18-22 SALMON STREET, PORT MELBOURNE

**LOCATION/ADDRESS:** 18-22 SALMON STREET, PORT MELBOURNE  
**EXECUTIVE MEMBER:** LILI ROSIC, GENERAL MANAGER, DEVELOPMENT, TRANSPORT AND CITY AMENITY  
**PREPARED BY:** SIMON GUTTERIDGE, PLANNING TEAM LEADER FISHERMANS BEND

1.1 To provide a Council position for the Fishermans Bend Standing Advisory Committee on an application to the Minister for Planning to prepare, adopt and approve an Amendment to the Planning Scheme under Section 20(4) of the Planning and Environment Act for 18-22 Salmon Street, South Melbourne.

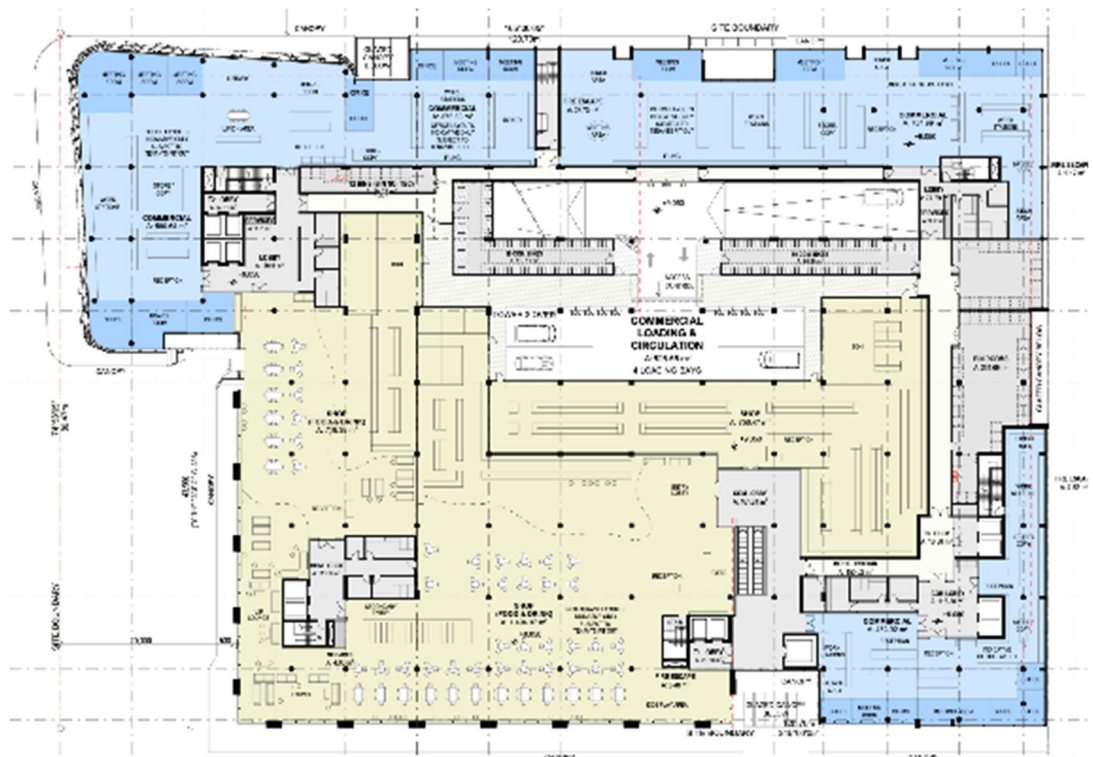
Council's Traffic engineers recommended the footpath step up from the vehicle carriageway and incorporate kerb and channel in lieu of the bollards and the carriageway and footpath be widened to maintain a consistent width so vehicle turning paths did not encroach on and require tapering of the footpath the junction with Salmon Street as currently proposed.

They also raised a concern the combined width of the three (3) vehicle entries at the eastern end of the land created multiple conflict points for vehicles and pedestrians and recommended the crossings be consolidated, a pedestrian refuge be provided and the building vehicle entries be setback further from the footpath to improve turning movements.
